MIDLAND PROJECT

INFORMATION ON SEISMIC CATEGORY I MASONRY WALLS  
FOR THE STAFF'S SAFETY EVALUATION REVIEW

REVISED RESPONSE TO APRIL 21, 1980  
NRC QUESTION 5

ALLOWABLE DESIGN LOADS FOR WEDGE AND STUD TYPE ANCHORS  
IN  
MASONRY BLOCK WALLS

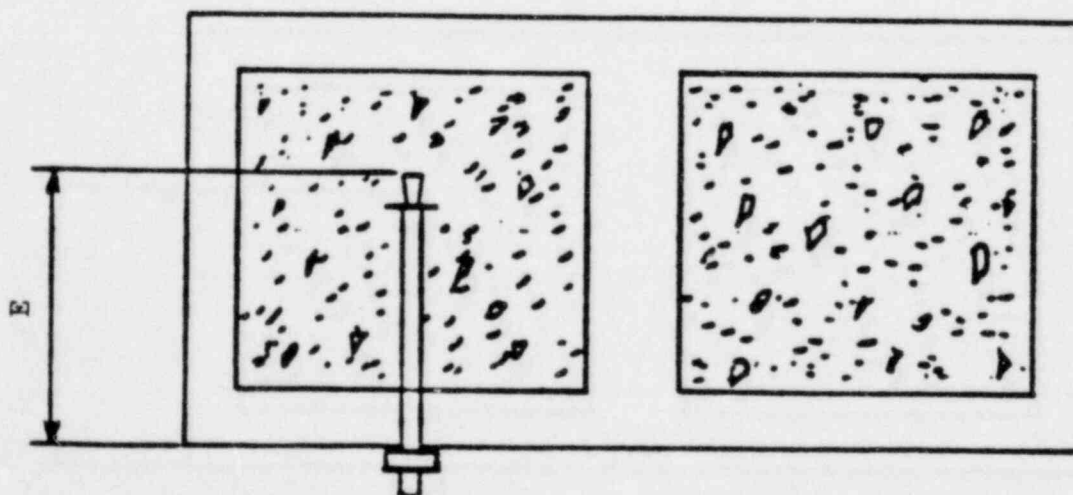
How were the masonry walls and the piping/equipment supports attached to them designed? Provide enough numerical examples including details of reinforcement and attachments to illustrate the methods and procedures used to analyze and design the walls and the anchors needed for supporting piping/equipment (as applicable).

Items supported by Seismic Category I masonry walls are limited to small piping and light weight equipment. They are attached by expansion anchors, grouted anchors, or through bolts.

The design information for expansion anchors is shown in Attachment 1.

Anchor Diameter (in.)	Minimum Embedment (E) Before Torquing (in.)	Tension (T) (kips) <sup>1</sup>	Shear (S) (kips) <sup>1</sup>	Spacing (in.)
3/8	1-5/8	0.4	0.5	4
3/8	3-1/8	0.6	0.8	4
1/2	2-1/4	0.7	1.4	5
1/2	3-3/4	0.8	1.6	5
5/8	4	1.2	2.2	6
5/8	5-1/2	1.6	2.4	6

- 1) Values based on "Report on the Testing of Concrete Expansion Anchors in Masonry Blockwalls" at Midland Michigan.
- 2) When an anchor is subjected to both tension and shear loads, the following method of combination shall be used to assess anchor capacity:

$$\frac{S_{\text{applied}}}{S_{\text{allowable}}} + \frac{T_{\text{applied}}}{T_{\text{allowable}}} \leq 1.0$$
